Burlington Design Advisory Board

**ZP-25-92; 24 Grant Street (RM, Ward 3) 24 Grant Street, LLC / Doug Viehmann
Post fire rehabilitation, creating one additional residential unit as allowed under
the Historic Building Rehabilitation Bonus. Project review under Planned Unit
Development (PUD) standards. (Project Manager, Mary O’Neil)**

MEMORANDUM

To: The Design Advisory Board
From: Mary O'Neil, AICP, Principal Planner
RE: ZP-25-92
Location: 24 Grant Street
Date: April 8, 2025

1967 Polaroid photo of 24 Grant Street.
Note fenestration pattern.

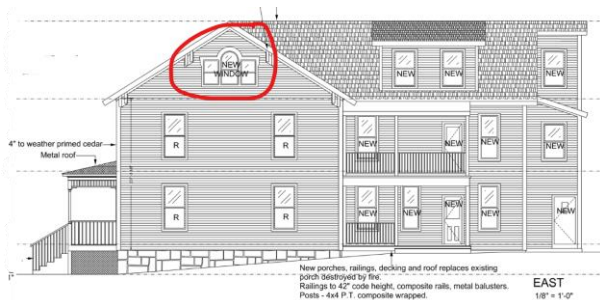
Replacement windows are proposed for the rear/north addition and the gable-end of the historic home. The application proposes restoration of the existing windows on that portion of the structure. Plans define 1/1 windows there, while historic photos, current photos and the Vermont State Register listing illustrate a 2/2 fenestration pattern which shall be retained or duplicated.

The replacement gable end windows differ from existing conditions by creating a three-part arrangement with an archtop window in the center, without muntins. This alters the characteristic single arch-top window that historically existed; its replacement a diminishment of an identified historic characteristic of the listed historic structure. This is a feature that is represented in other neighboring structures, and singularly identified in the Vermont State Register listing. (*Round headed gable window with shouldered architrave.*)

From floor plans, the alteration is proposed in support of living area on the third floor in the new 6th residential unit. The rehabilitation will include sprinklering, so the code requirement for larger windows is moot. The DAB must discern whether this loss of historic character and a specifically identified feature may be avoided or is an acceptable change to design and appearance.

SHEET:
SP

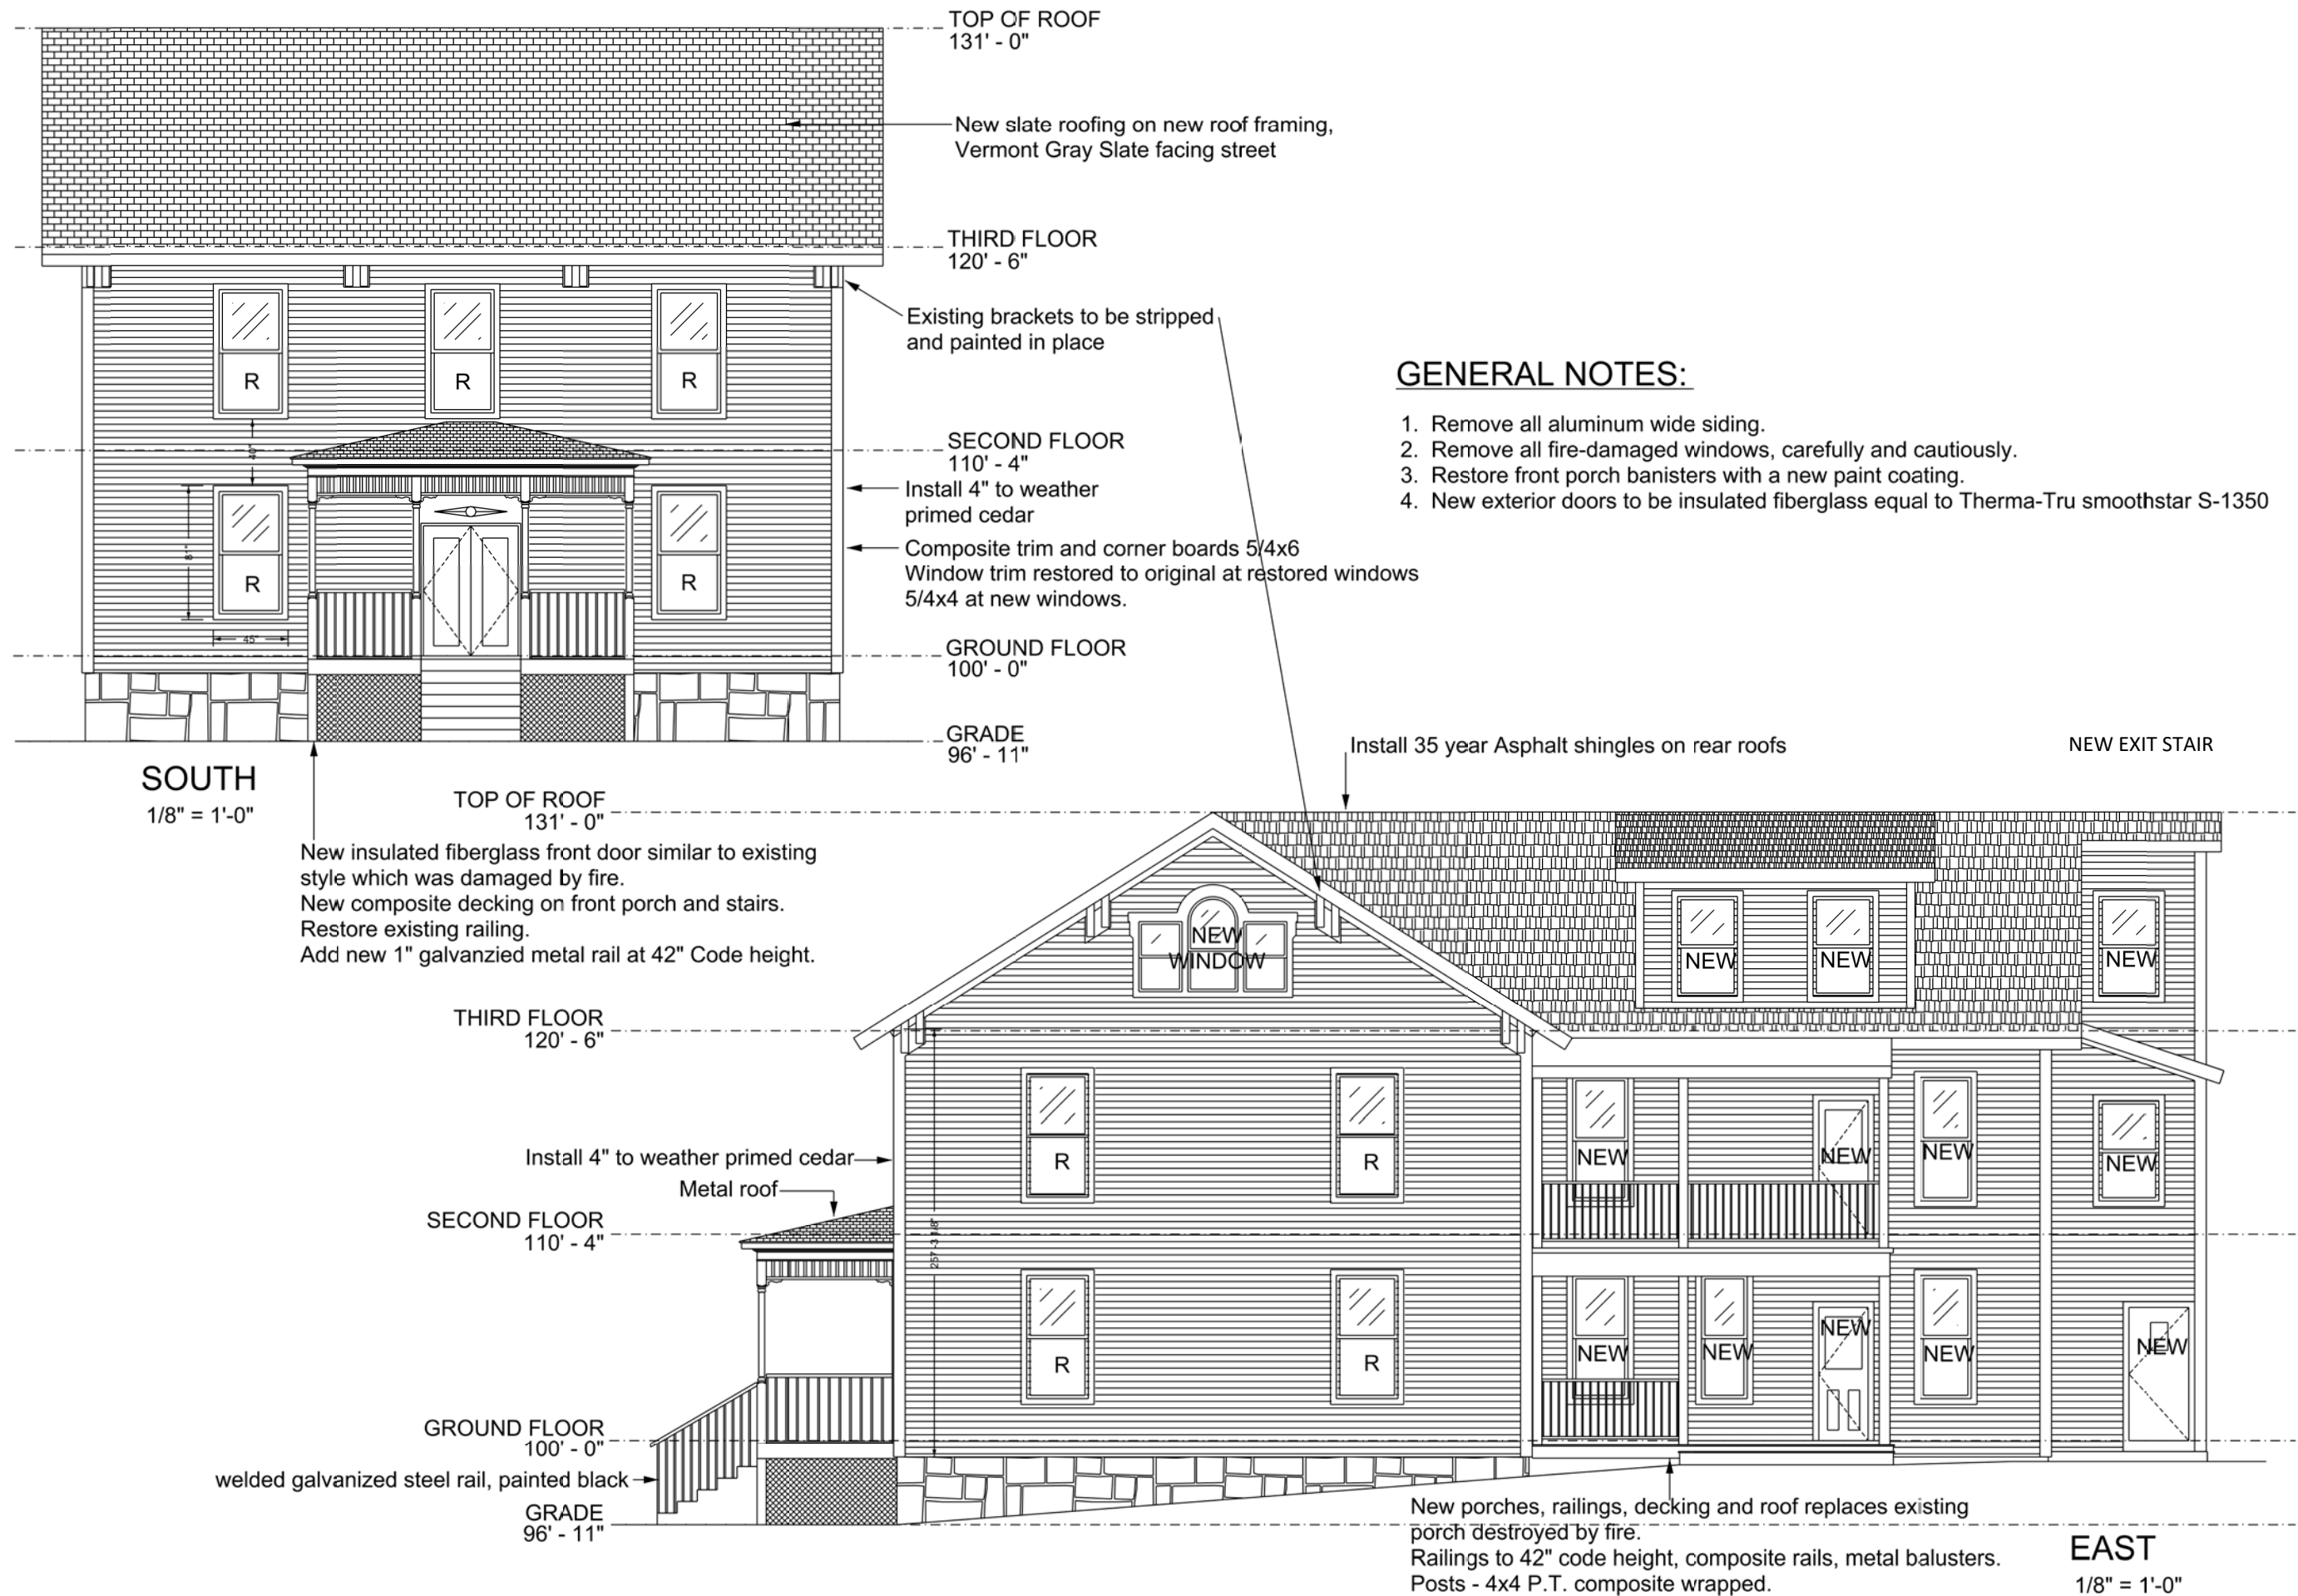
The approved 1983/1983 site plans illustrate two curb cuts, each leading to parking areas/garage. The proposed site plan modifies the 1983 plan by connecting the two vehicular areas, adding to the lot coverage and minimizing green space. The east driveway is well defined, but the westerly access has created the equivalent of a shared driveway with 16 Grant Street with expansive gravel. It certainly would be possible to minimize the lot coverage and more clearly define the access/parking in this area.

The site plan has functionally changed in that the two access drives (east, west) have been connected in a gravel lane between the buildings; eliminating the 2 parking spaces in

front of the garage, and expanding the gravel onto the 16 Grant Street parcel. While parking minimums are no longer applicable, there are opportunities to minimize lot coverage, enhance the landscaping, provide areas of natural stormwater infiltration and provide a greater area for resident enjoyment of the yard with a return to the 1983 plan. (Lot coverage has increased from 62% in 1983/1986 to almost 72% now.)

There is no requirement for a public plaza; however PUD standards require outdoor areas for resident use. [Section 11.1.5 (g)] The alteration of the 1983/1986 site plan has reduced the grassy area and increased lot coverage. At present, there are no identified outdoor areas for residential use, other than a new two story porch on the east. Landscape enhancements and minimized lot coverage are recommended to meet this requirement.

DATE: 28 JAN 25
REVISED:
SCALE:
1/8" = 1'-0"
DRAWING:
ELEVATIONS
SHEET:
A2.2

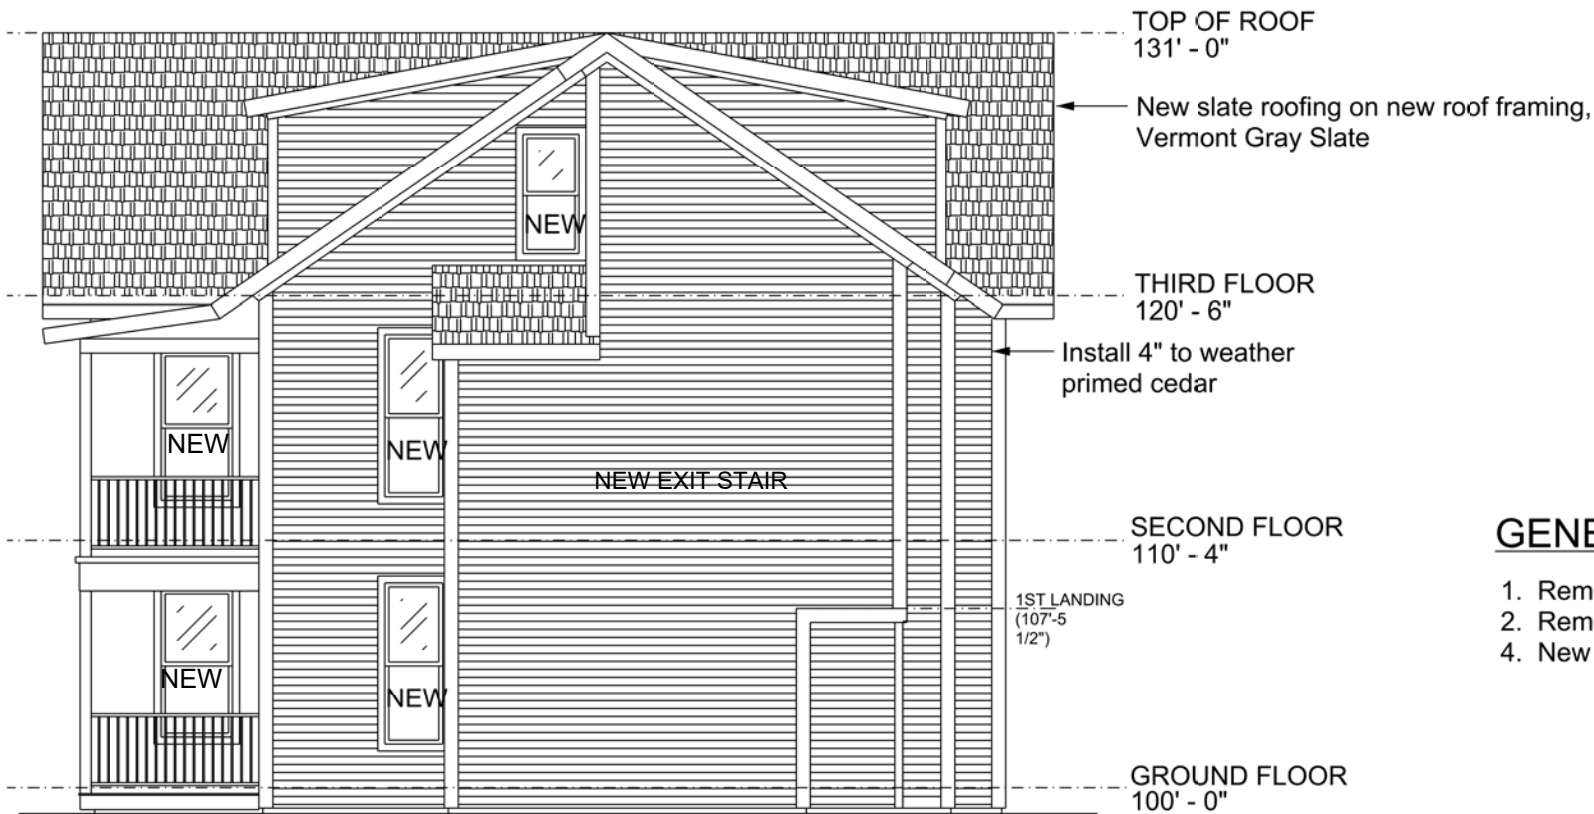
The application proposes re-installation of a Vermont Strata Gray slate roof on the primary structure, while the rear addition will have asphalt shingles. See Plans A 2.1 and A 2.2.

Removal of the aluminum siding and restoration of the porch, siding, windows and roof will be positive steps in reclaiming/retaining historic character. The removal of the archtop gable window will be a loss to the historic merit of the property and therefore recommended for plan revision.

The gable end archtop attic window is a distinctive feature that should be retained. A tri-part window arrangement is not consistent with the historic character of the property.
